MEMORANDUM

REVIEW TYPE: Site Plan Review
APPLYING FOR: 277 one-family detached dwelling units, 371 townhouses, 196 multi-family dwelling units, including 121 MPDUs on 209.27 acres

PROJECT NAME: Greenway Village Phases 3,4 and 5
CASE #: 8-04022
REVIEW BASIS: Sec. 59-D-3, M. C. Zoning Ordinance
Section 19-64 for Final Water Quality Plan
ZONE: PD-4 zone
LOCATION: Northeast quadrant, of the intersection of Skylark and New Cut Road;
Clarksburg & Vicinity,
MASTER PLAN: Clarksburg Master Plan and Hyattstown Special Study Area, June 1994
PA-19
APPLICANT: Clarksburg Skylark LLC, Bernard Rafferty contact person
FILING DATE: March 8,2004
HEARING DATE: July 22, 2004

Greenway Village Local Park

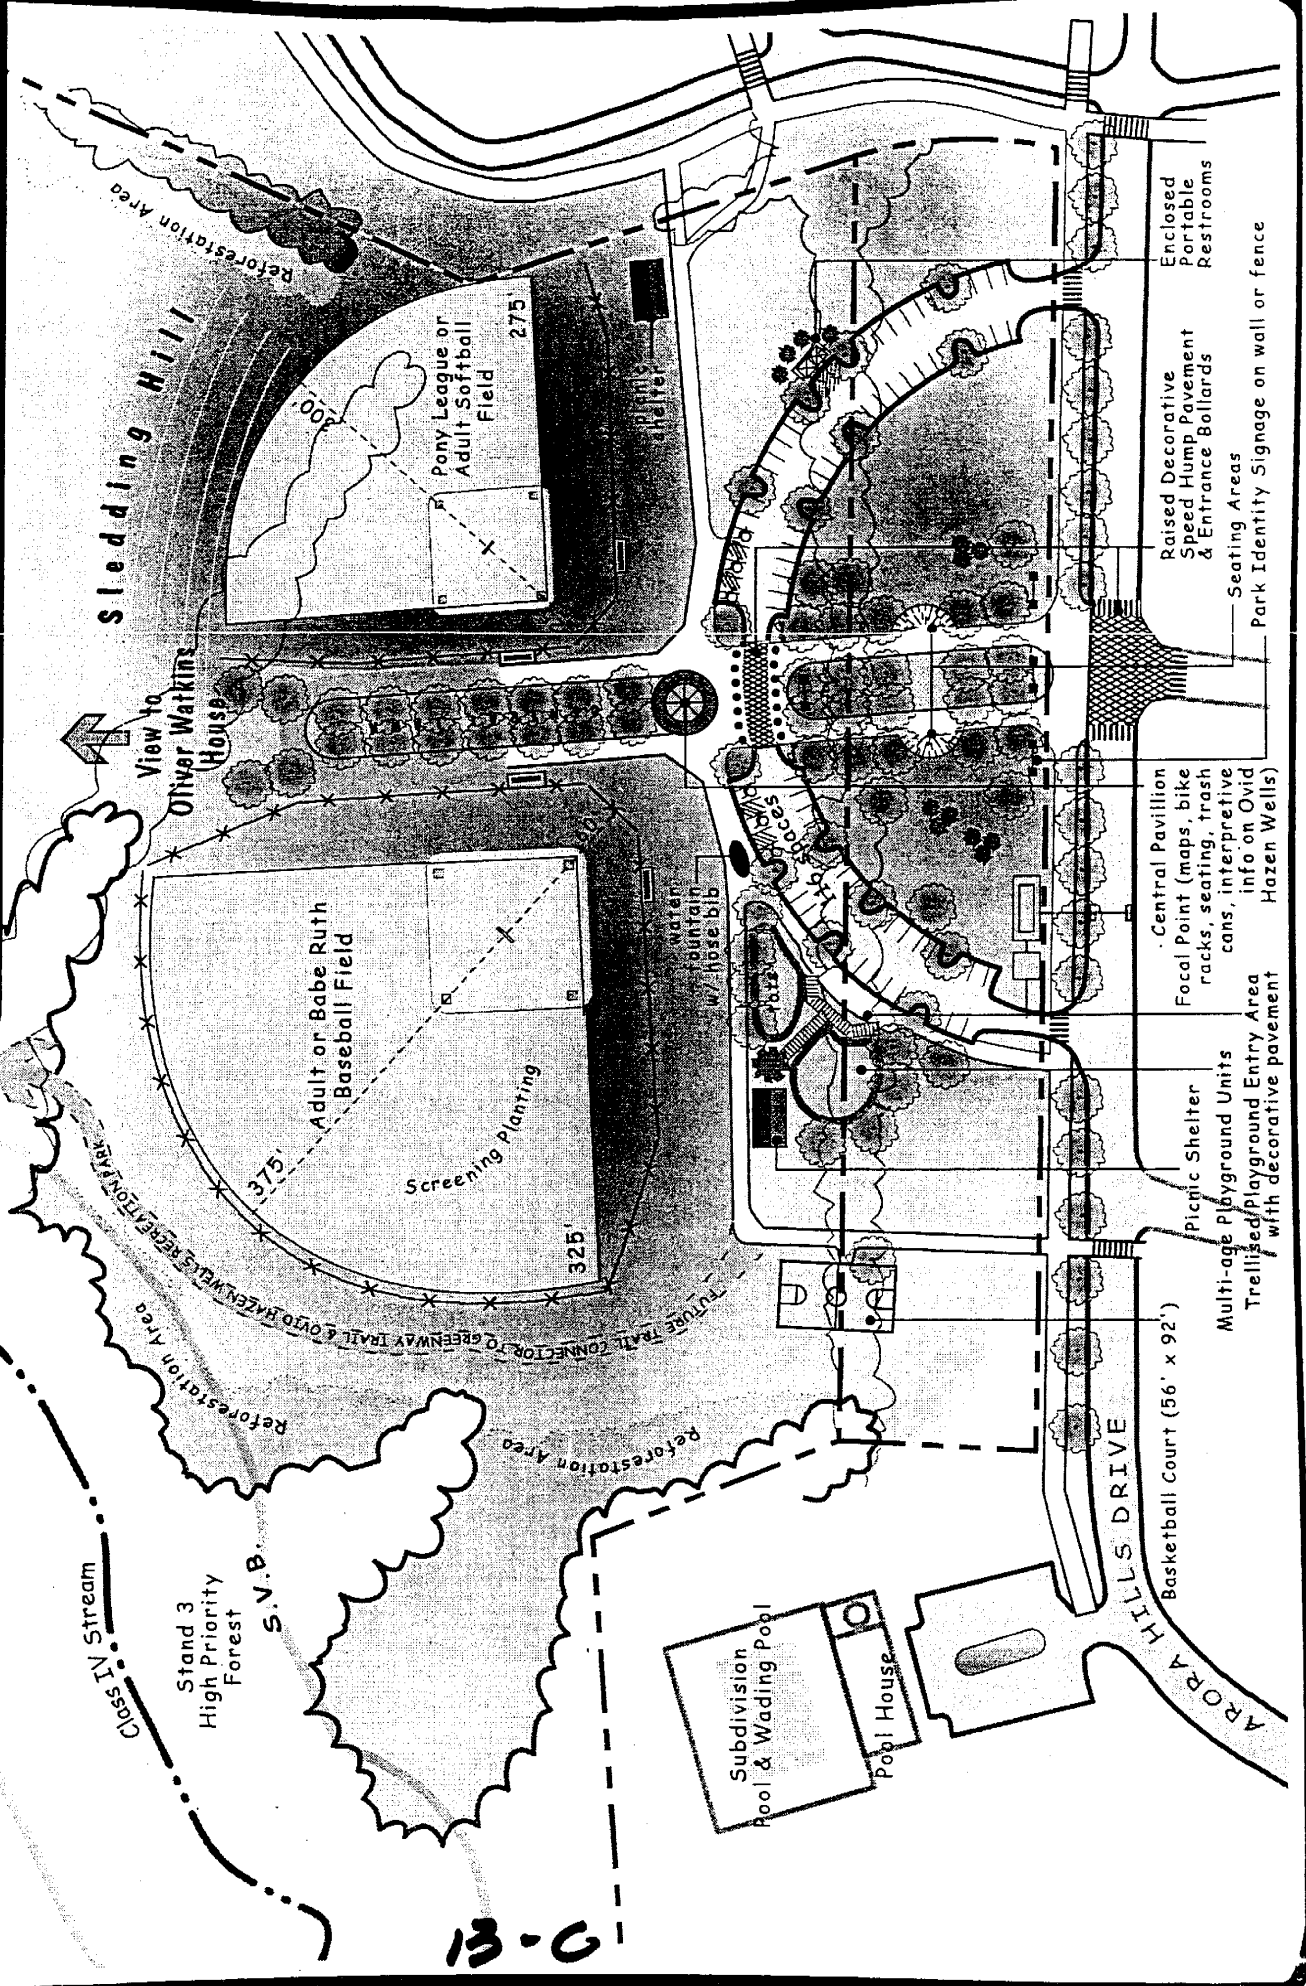
- D. Applicant to engineer and construct, to park standards and specifications, on dedicated Park 19 and adjacent parkland currently a part of Ovid Hazen Wells Recreation Park, the following Local Park facilities and amenities:

1. Two (2) adult sized baseball fields with appropriate fencing, backstop, benches, grading, seeding and landscaping as determined by M-NCPPC staff to meet current park field standards and specifications. Exact size of baseball fields to be determined by M-NCPPC staff.

2. Adult sized basketball court at least 56' x 92' with poles, backboards, hoops, nets, court surfacing and benches as determined by M-NCPPC staff to meet current park standards and specifications.

3. Two (2)-picnic shelters sized to accommodate at least 4 picnic tables with 4 picnic tables installed per shelter.
 4. A centrally located water line with at least 1 ½ inch diameter and hose/irrigation system connections from said water line to each baseball field. Drinking fountain to also be installed at central location. Location of fountain and hose/irrigation system connections to be coordinated with M-NCPPC staff.

5. Raised, grass playing and sports viewing berms/knolls at locations to be determined by M-NCPPC staff.
 6. A multi-age play area with play equipment, multi-height pergola, structures and seating to be determined by M-NCPPC staff.

7. A centrally located linear grass mall/green boulevard area with 10' wide paved walkways on both sides, seating, decorative stamped/colored concrete paving areas, bollards and/or stone piers, and a central feature(s) such as a pavilion, kiosk or other focal structure. Choice and details of structures and features to be determined by M-NCPPC staff in coordination with Special Protection Area guidelines.

8. Curved parking lot for 116 cars with tree islands interspersed throughout and curbing and wheel stops as acceptable to M-NCPPC staff.

9. Concrete pad for portable toilet(s) in a location and size to be determined by M-NCPPC staff.
 10. Landscaping, benches, seating areas, curbing, bollards, bike racks, trails, walls and fencing throughout the park as determined by M-NCPPC staff to meet the needs of the Local Park users and create an aesthetically pleasing park experience.
